KPA500 KIT ASSEMBLY MANUAL ERRATA

Rev F9-2, March 9, 2020

Figure 19. Installing the Fan

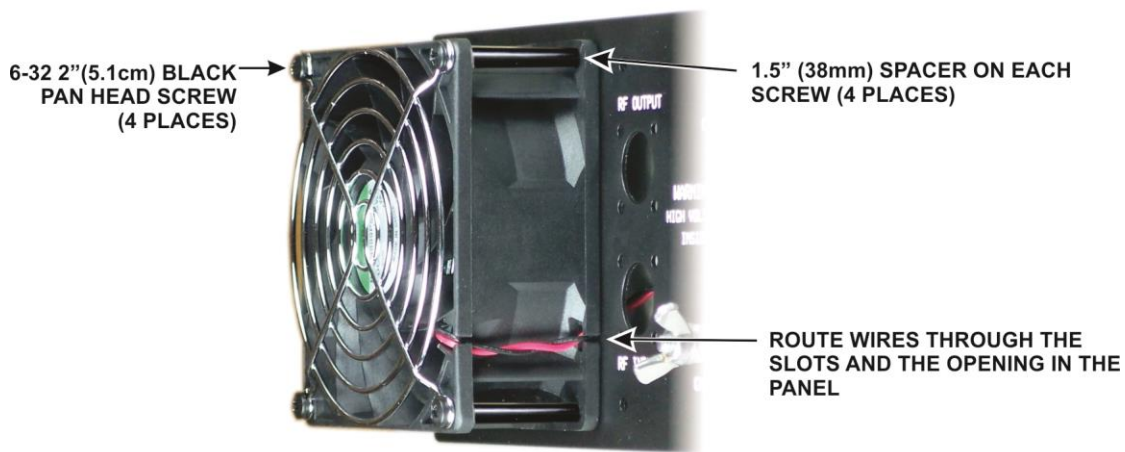
2. **Page 17, Figure 19:** Replace the figure with the following showing spacers placed on the mounting screws between the front and rear corner tabs on the fan housing.
